**DESIGN REVIEW COMMISSION
MUNICIPAL CENTER COUNCIL CHAMBERS
Tuesday, February 28, 2012
6:00 p.m.**

3. Chili's Restaurant – 7801 Poplar Ave., Germantown Collection – Request Approval of Building Façade Modifications.

4. Elysium Planned Unit Development, North side of Poplar Ave., Opposite Ashmont Road and Featherleigh Lane – Request Preliminary and Final Plan Approval for Landscaping, Fencing, Entrance Features and Lighting.

ONE (1) REQUIRED
RCL "Chili's" Word-Mark - HALO LIGHTED

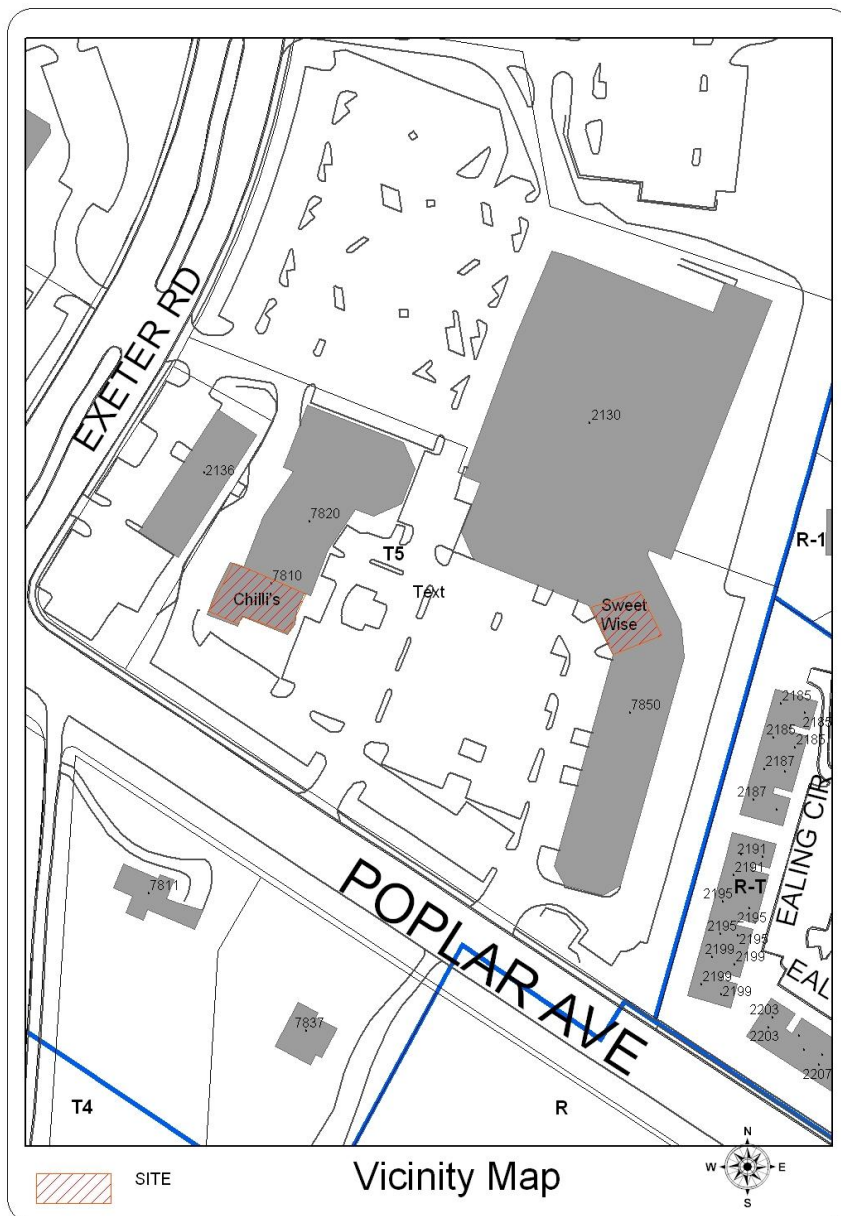
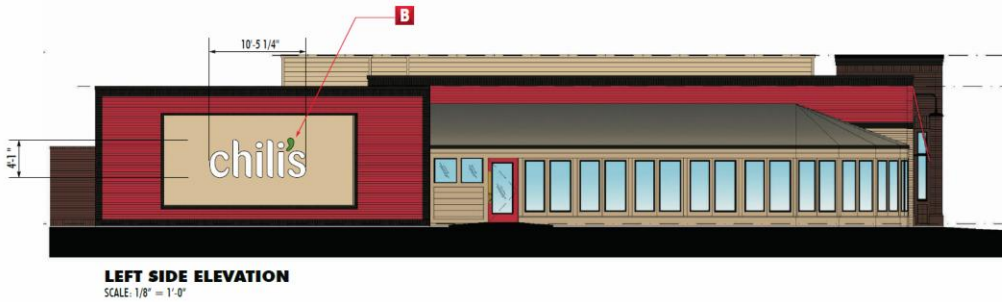
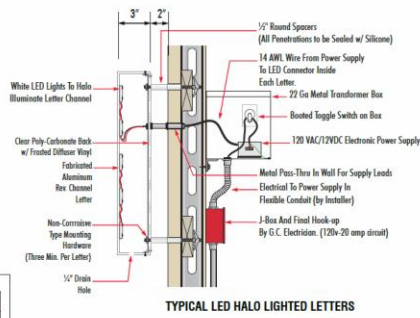
4. The proposed sign one complies with the Sign Regulations and the Germantown Collection sign policy in terms of the overall sign size, location, and material. Sign 2 complies in terms of sign size and material, and requires DRC approval because it is to be located on a wall without an entrance. The sign policy requires all signs with logos and fonts other than Palatino and Palatino Bold to obtain approval from the DRC.
5. Prior to DRC approval, the applicant shall provide the Disclosure of Ownership Interests.
6. If approved, the applicant must obtain a permit from the Memphis / Shelby County Office of Code Enforcement prior to installing the signs.

GERMANTOWN, TN – EXTERIOR ELEVATIONS

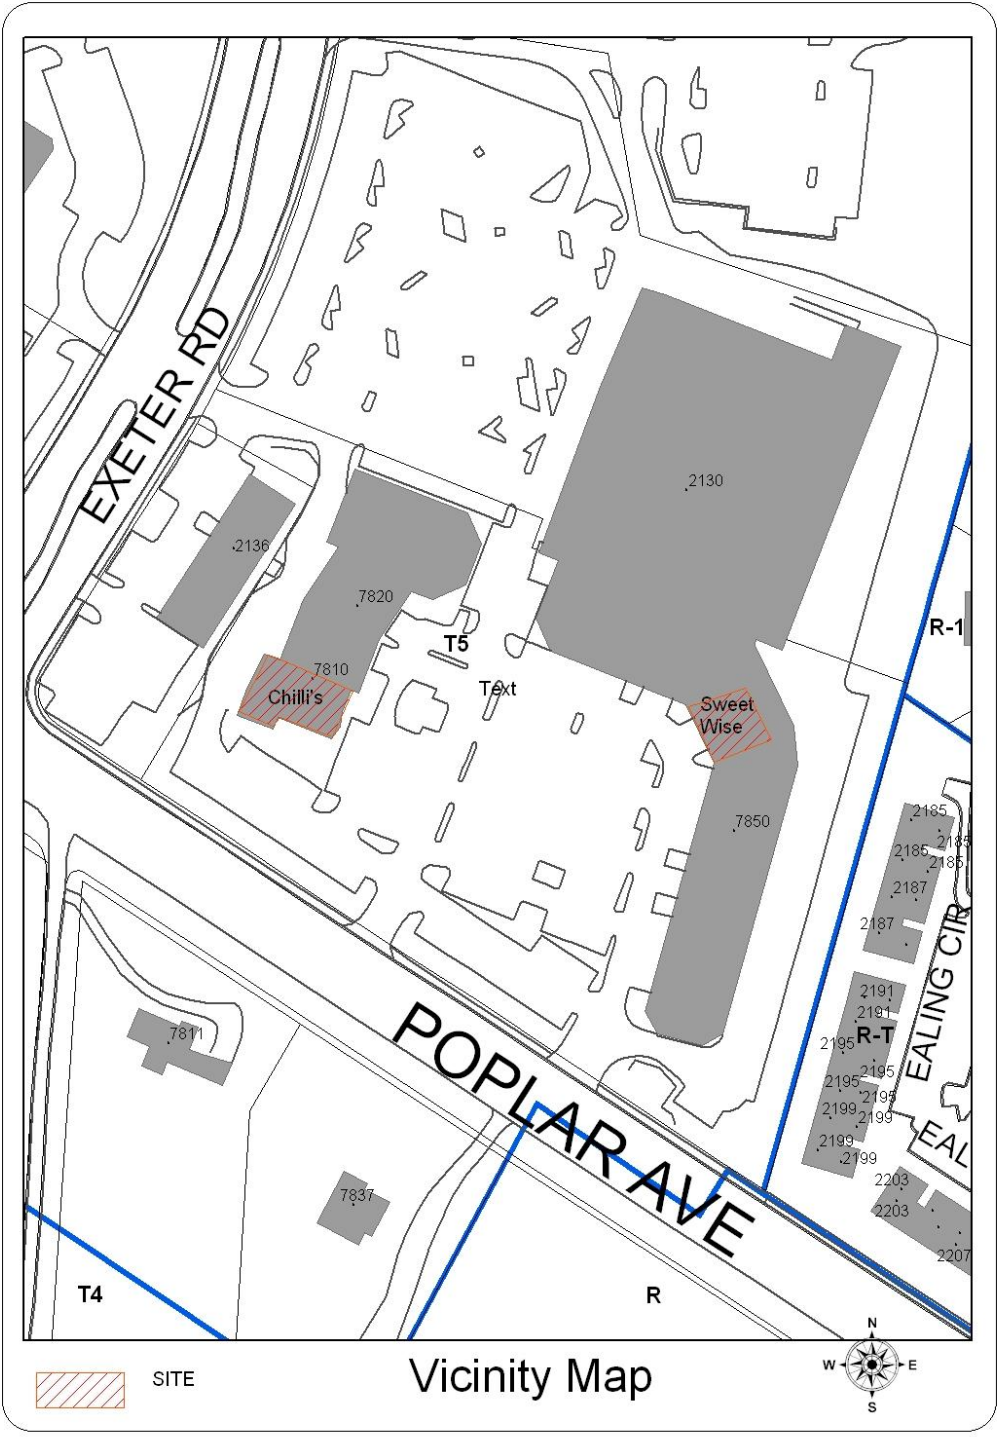
1. Prior to DRC approval, the applicant shall provide the Disclosure of Ownership Interests.
2. Larger paint color samples shall be provided at the DRC meeting.

After much discussion the board explained that the Chili emblem will need to be removed from the awning and the red paint that they have chosen for the brick will need to be toned down to a more earthy color. Staff was asked to get with the City of Germantown's Fire Marshall concerning the signage and the fire lanes accessibility that is located in the back of the restaurant.

PROPOSED MOTION: To approve the request to paint the exterior and install awnings at Chili's, at 7801 Poplar Ave., subject to staff comments and the building elevation diagrams filed with the application.

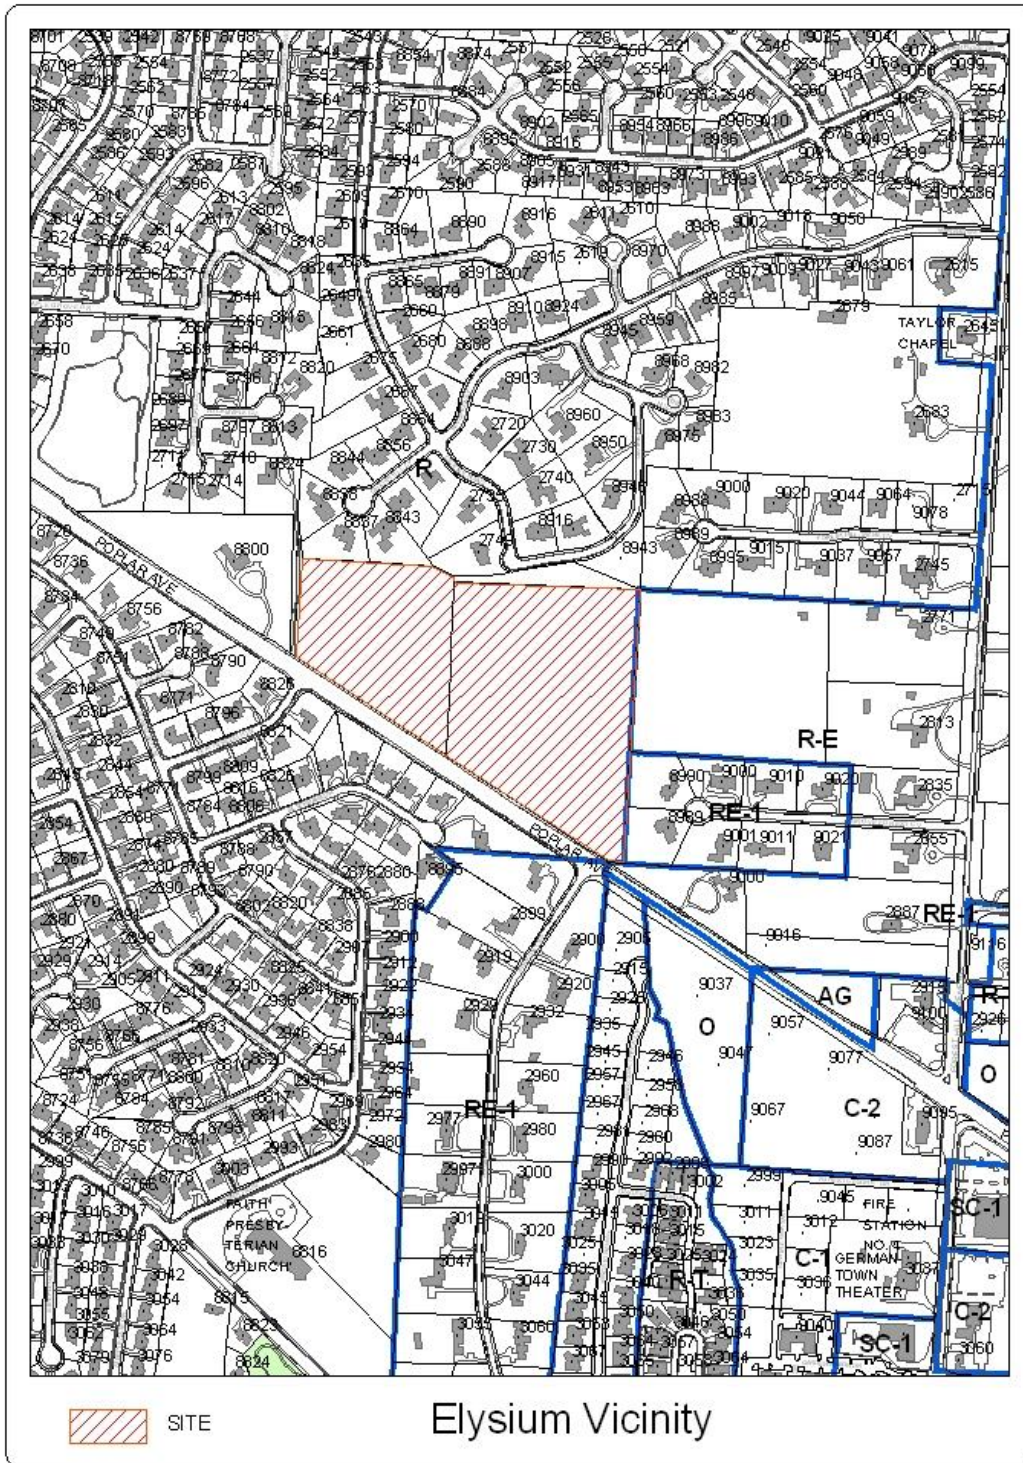
1. Street lights are to be installed as part of the construction of each dwelling. If the installation of all street lights are not completed by the end of the warranty period, the developer shall either complete the installation or provide the City with an irrevocable letter of credit satisfactory to the City, a certificate of deposit from a federally insured financial institution with an office or branch in Shelby County, Tennessee, properly assigned to the City, or cash, so as to insure the completion of the installation.

Chairman Saunders expressed concern over the street lighting in the areas of the subdivision that do not develop as quickly as others. Mr. Thomas agreed that if no one had purchased the lot(s) by the “Initial

Mr. Andy Pouncey expressed concern over their choice of trees located at the entrance and how they would be affected by the over head power lines in the future. Mr. Thomas agreed to eliminate these trees and just leave this area as beds.

The board also requested that additional lighting at the entrance be added and that they also check with the US Postal Service concerning the size of the mail boxes so that they are sure it meets all of the postal requirements.

Acceptance” phase of this project then they would install and maintain the street lights until the new homeowner(s) takes possession.
